UNITED STATES PATENT AND TRADEMARK OFFICE

10/523,950

Office Action Summary	Application No. 10/523,950	Applicant(s) PRISMALL, IAN JAMES	
	Examiner NAHID AMIRI	Art Unit 3679

DETAILED ACTION

Fig. 1

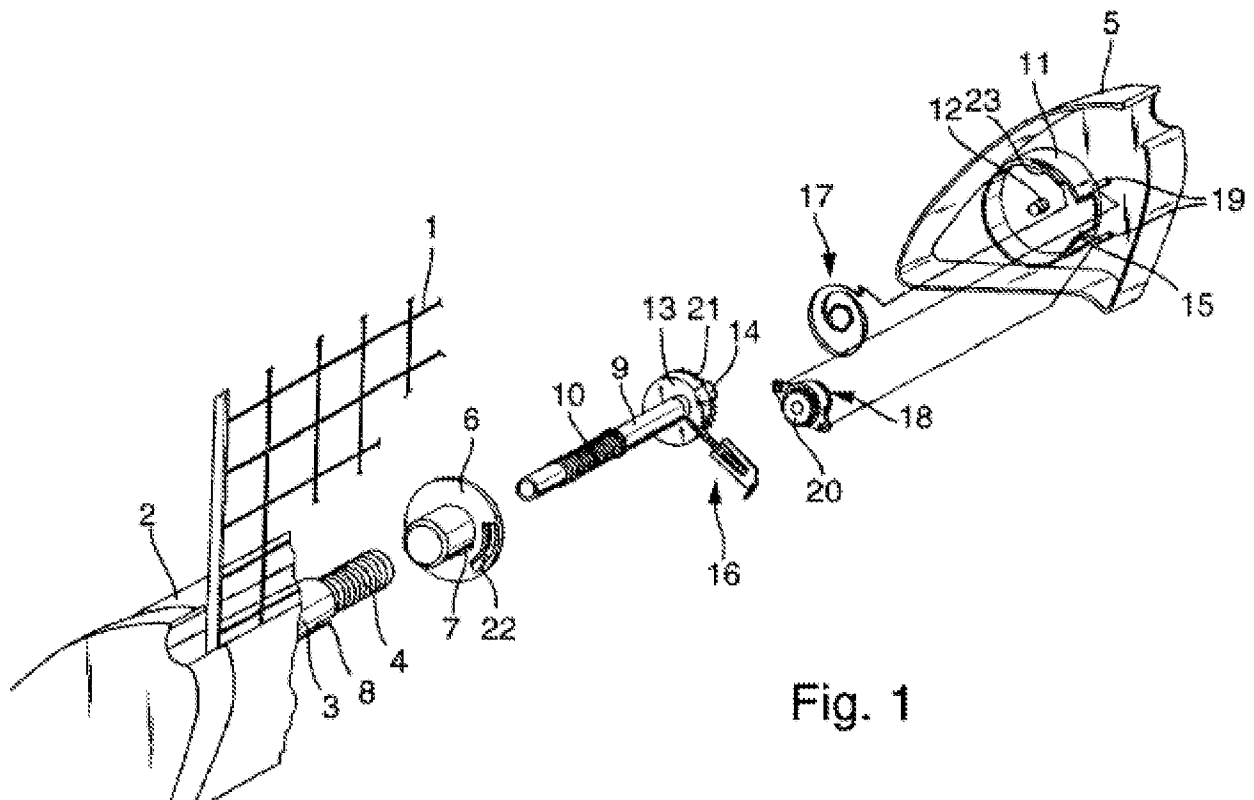
With respect to claims 1, 5-8, and 13, Ehrenberger et al. disclose a retractable barrier system (16, Fig. 1) comprising a support member (7), a spool (3) supported for rotation by the

support member (7), a spring (4) arranged to provide a biasing load to the spool (3), and a skirt (2) the spring (4) being located beneath the skirt (4) and the skirt (20) being arranged to deflect water away from the spring (4) which would otherwise impinge on the spring (4); wherein the skirt (2) is carried by the spool (3); having all the components of the barrier system such as the spool (3) and the skirt (2) are interconnected with each other that constitutes unitary with one another; further having a cover (constituted by a bearing sleeve 6), a closed compartment within the spring (4) is housed; wherein the cover (6) is secured to the skirt (2) by a least one a screw thread (10); further having a fixed spindle (9) supported by the support member (7) and upon which the spool (3) is mounted for rotation; wherein the spring (4) includes a first end part anchored to the support member (7) and a second end part is capable of driving the spool (3); and wherein the integrally formed skirt (2) and spool (3) capable of deflecting drain water radially outwardly, around and past the spring (4).
